PROJECT: 20-25 **New TK Classrooms - Monte Verde ES & Junipero Serra ES, Proj. Nos. 19-25 & 20-25**

BID ADDENDUM NO. 3

PROJECT: **Monte Verde ES TK Building**
2551 St Cloud Dr, San Bruno, CA 94066

DATE: February 26, 2026

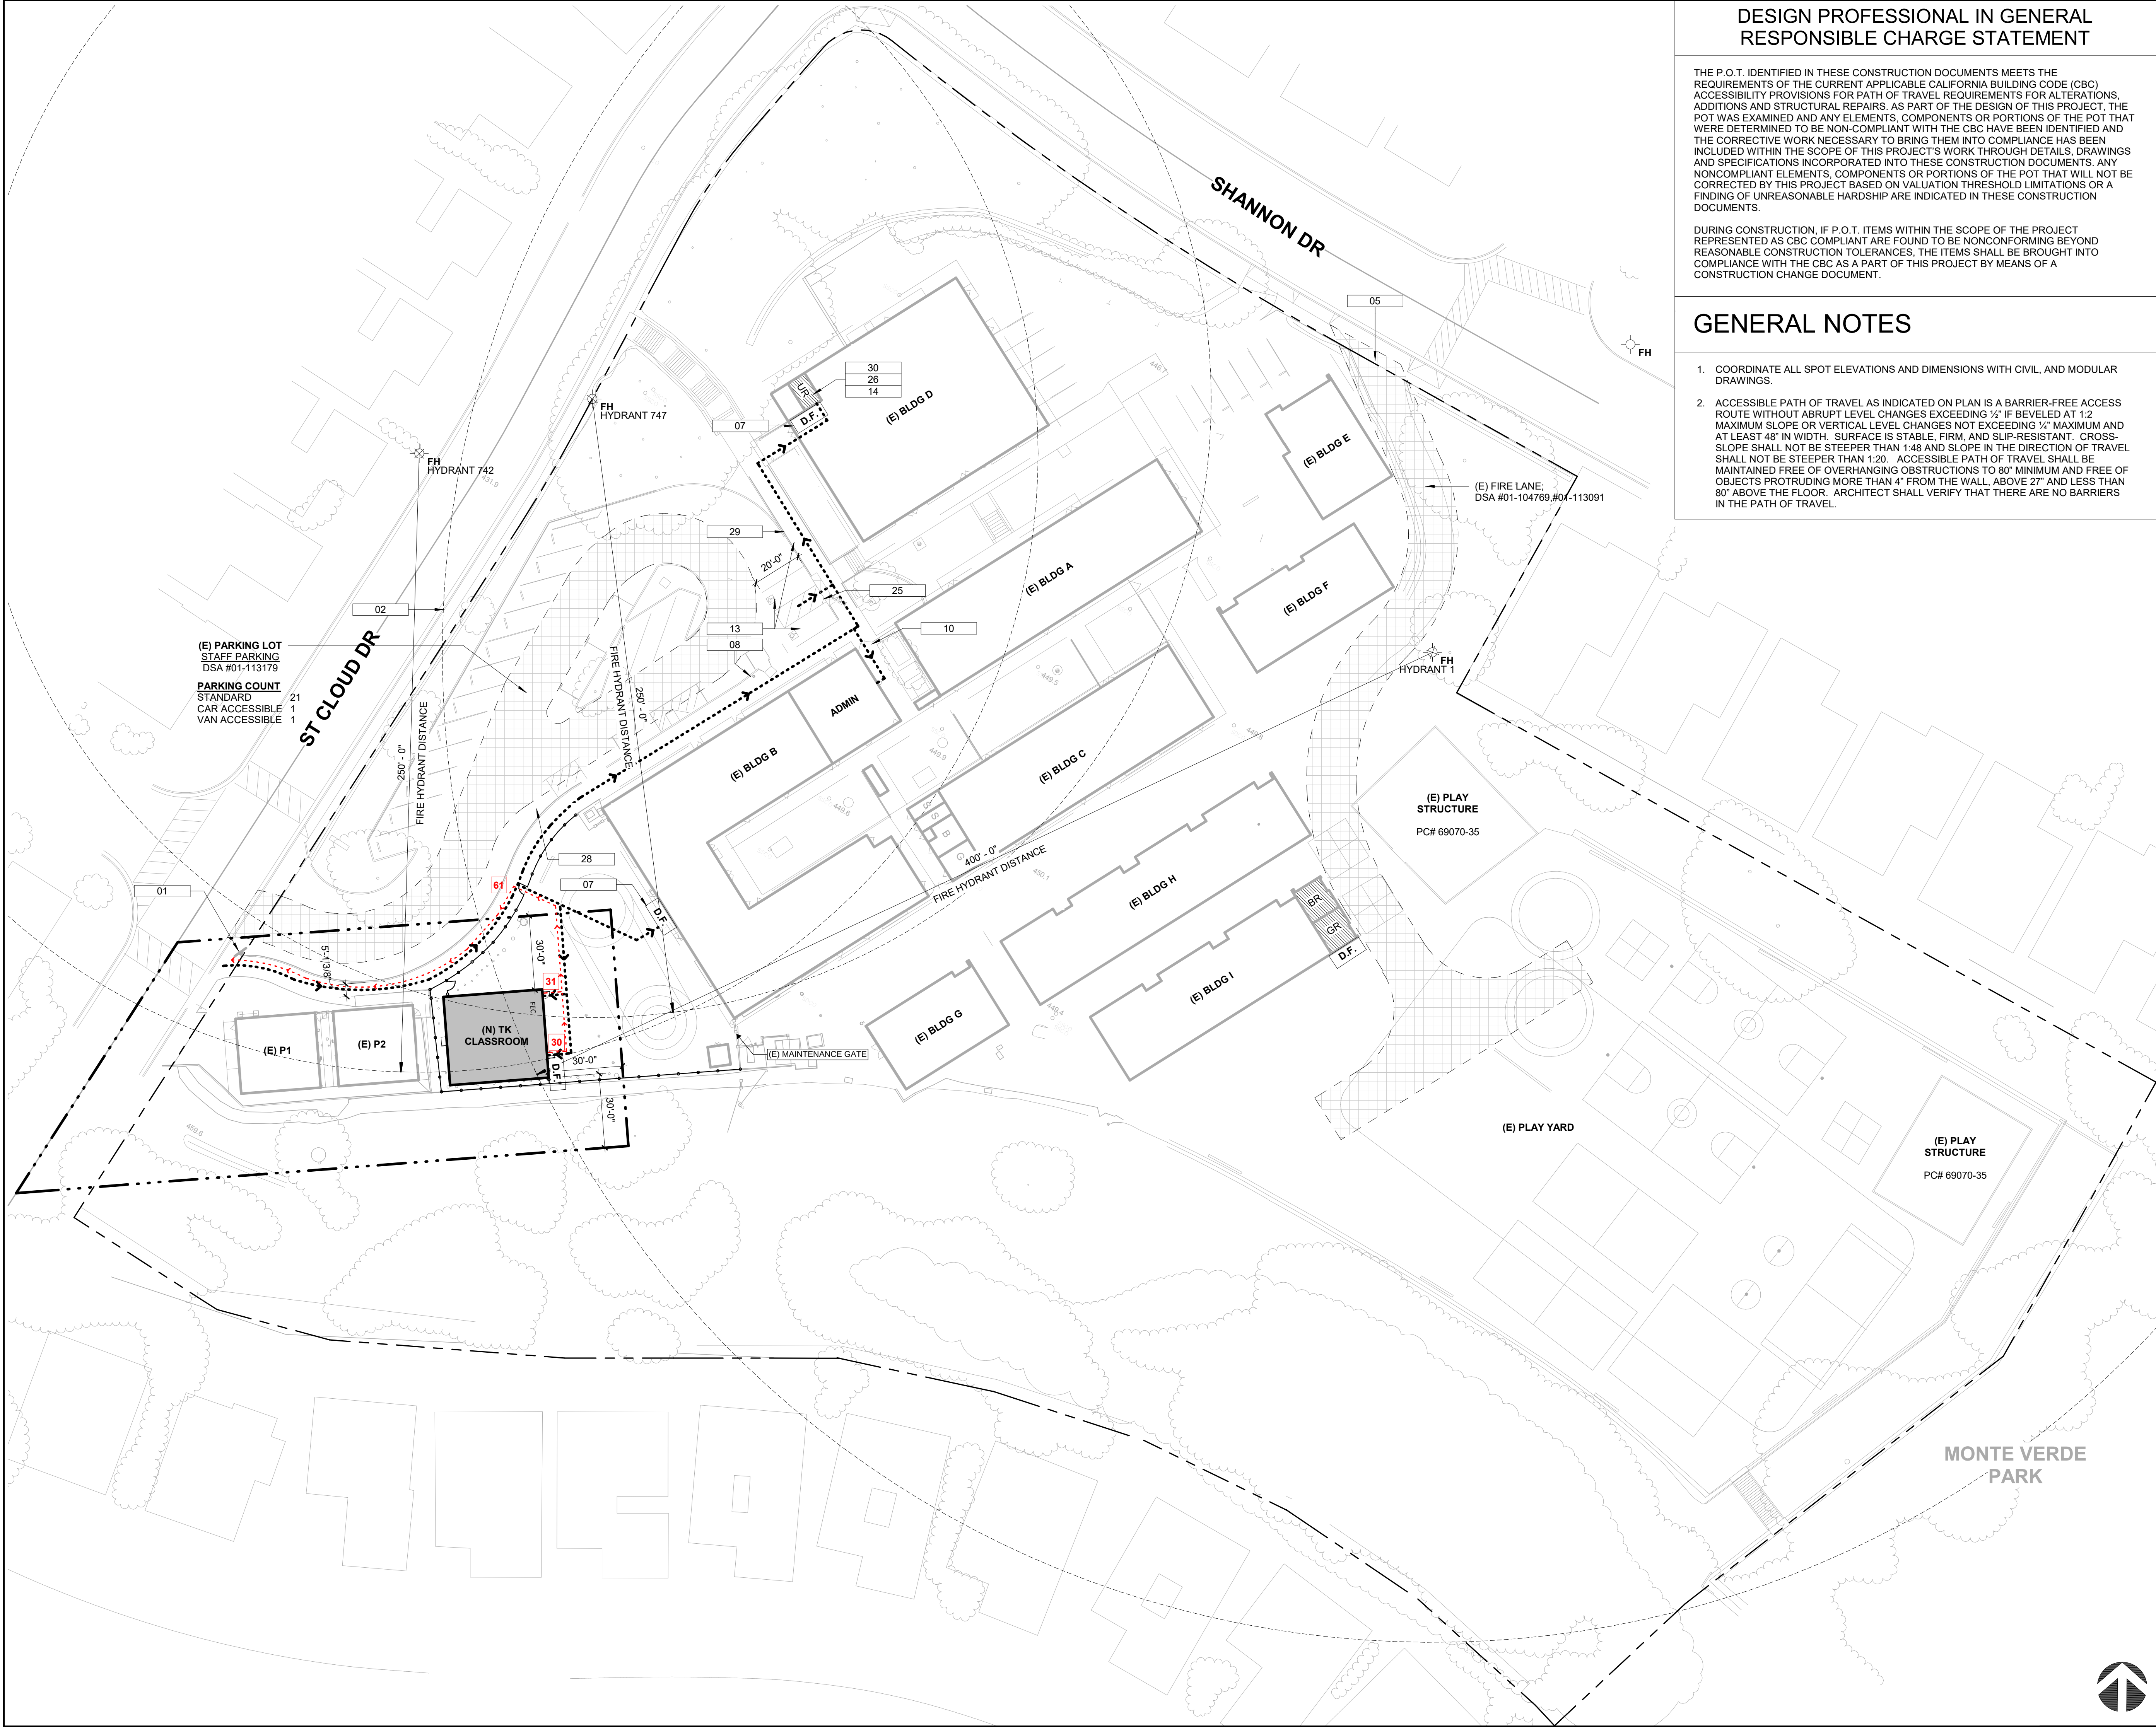
Sheet G0.01 – Updated scope of work to include bioretention, new play structure and revised fire alarm scope description. Added sheet A1.11 in the sheet index.

SITE PLAN 1" = 10'-0" 1

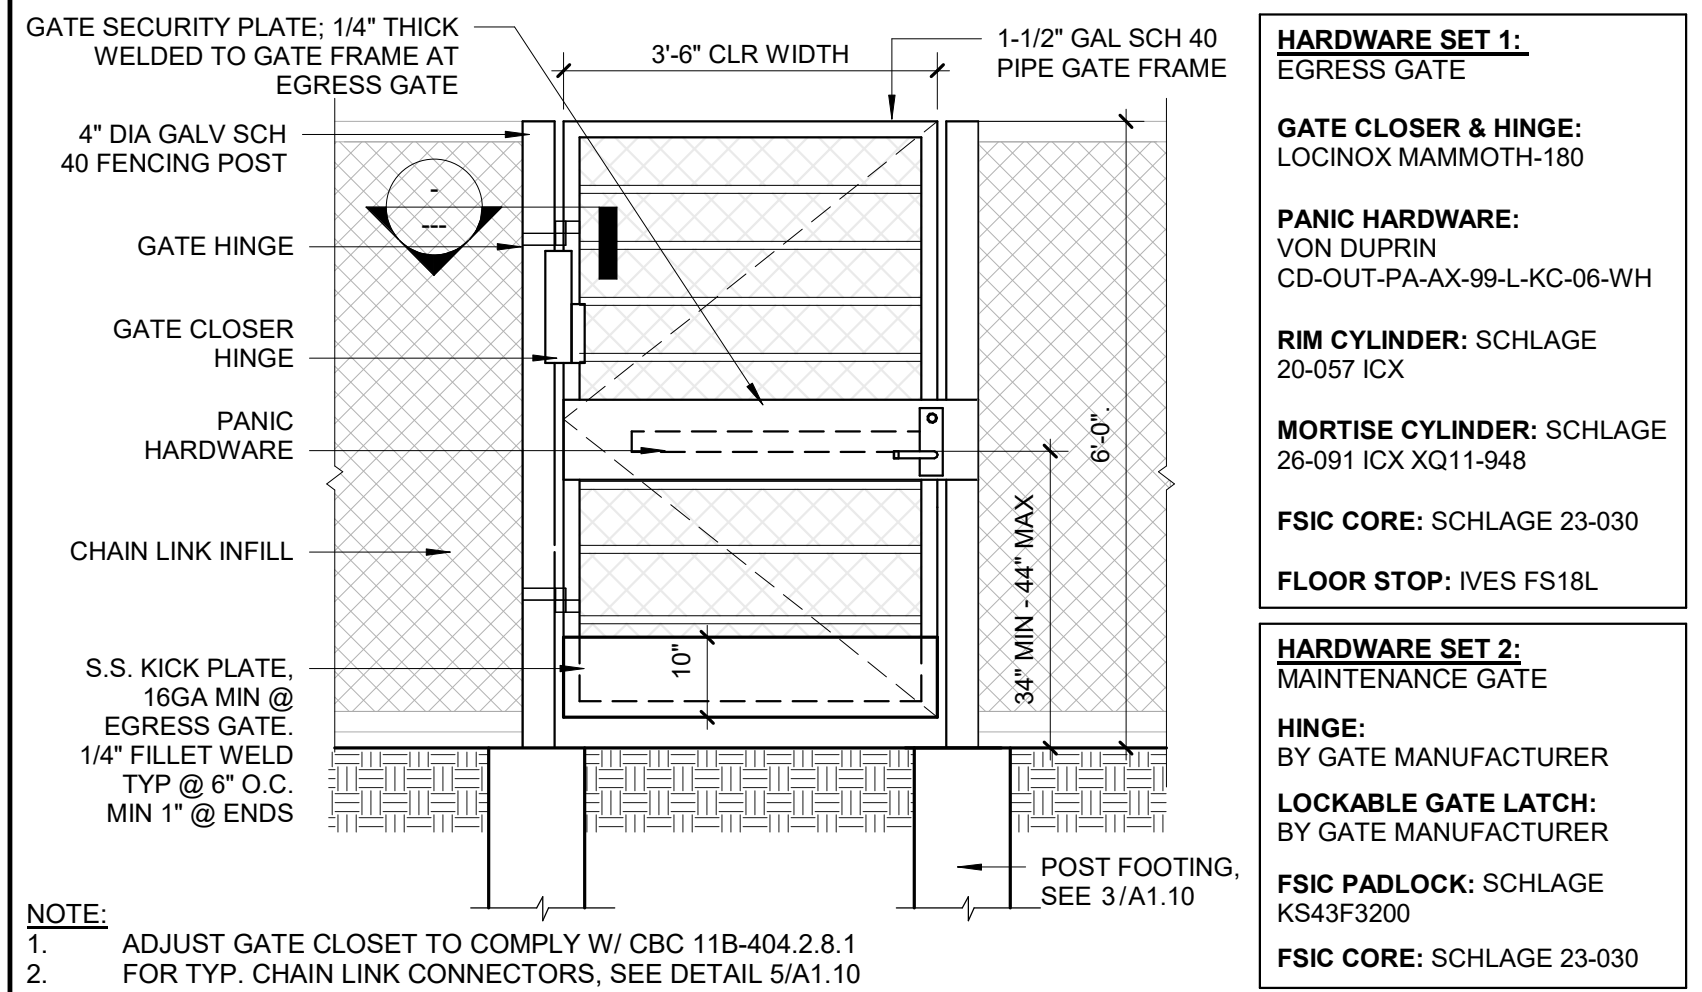
Sheet A1.10 – Added a play structure scope.
